PROJECT
DANTZIC BUILDING
Dantzic Street, Manchester. M4 4DE

Drawing Title
Elevation & Section Details on Windows W7.01, W7.07, W7.19 and W7.25
Level 7 (4th Flr) Dantzic & Federation Elevations

For Manufacture

DRAWING No.
3072 - 17
REVISION A

1 No.Total As Shown
W7.25 - Type E2 (to Disable WC)
Federation St. Elevation

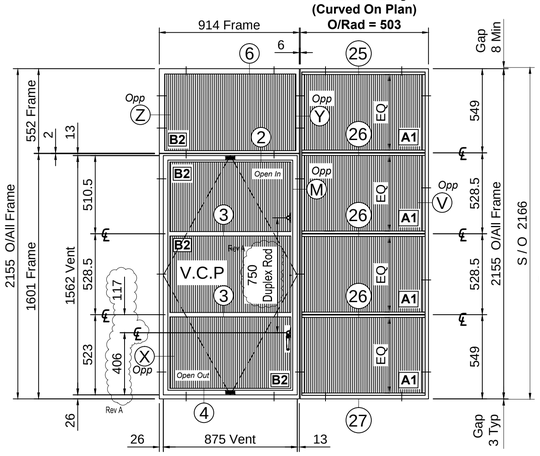
Rev	Date	AMENDMENT
A	23.01.18	Updated to Manufacture Issue; Duplex Rod size now 750mm; Duplex Handle height dims off vent and intermediate transom amended and added respectively; Notes added, omitted and amended as per revision clouds; Indicative Reeded glass hatching added to W7.25 elevation; Outside panes amended to Glass Specs 'A1' and 'B2'; Glass Spec 'B' added.

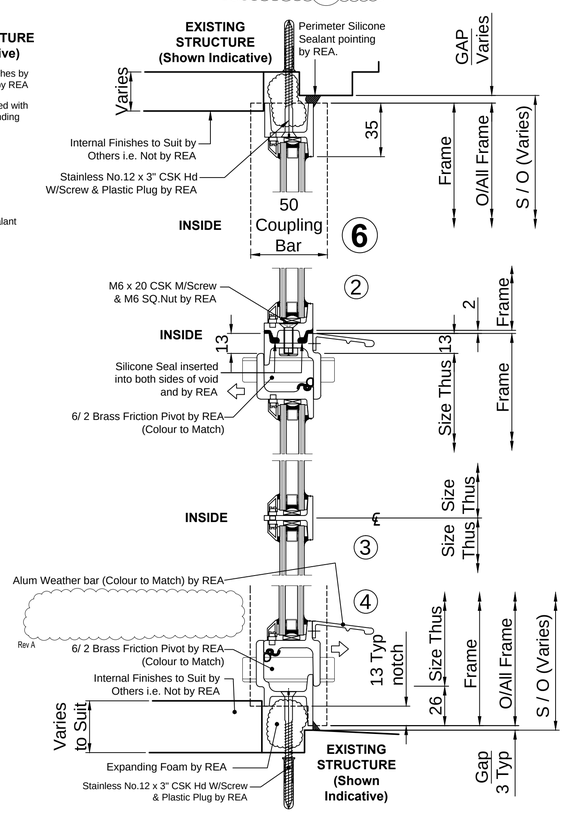
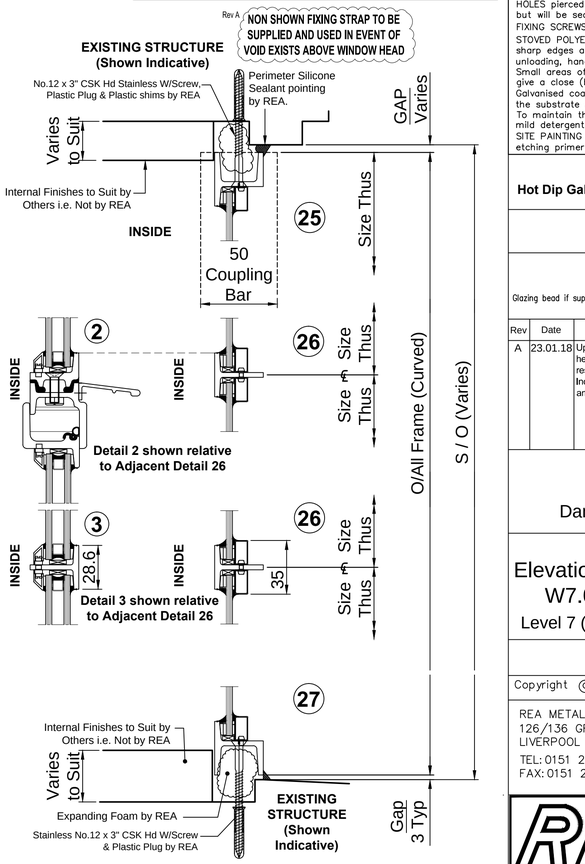
Rev A
NON SHOWN FIXING STRAP TO BE SUPPLIED AND USED IN EVENT OF VOID EXISTS ABOVE WINDOW HEAD

Rev A
NON SHOWN FIXING STRAP TO BE SUPPLIED AND USED IN EVENT OF VOID EXISTS ABOVE WINDOW HEAD
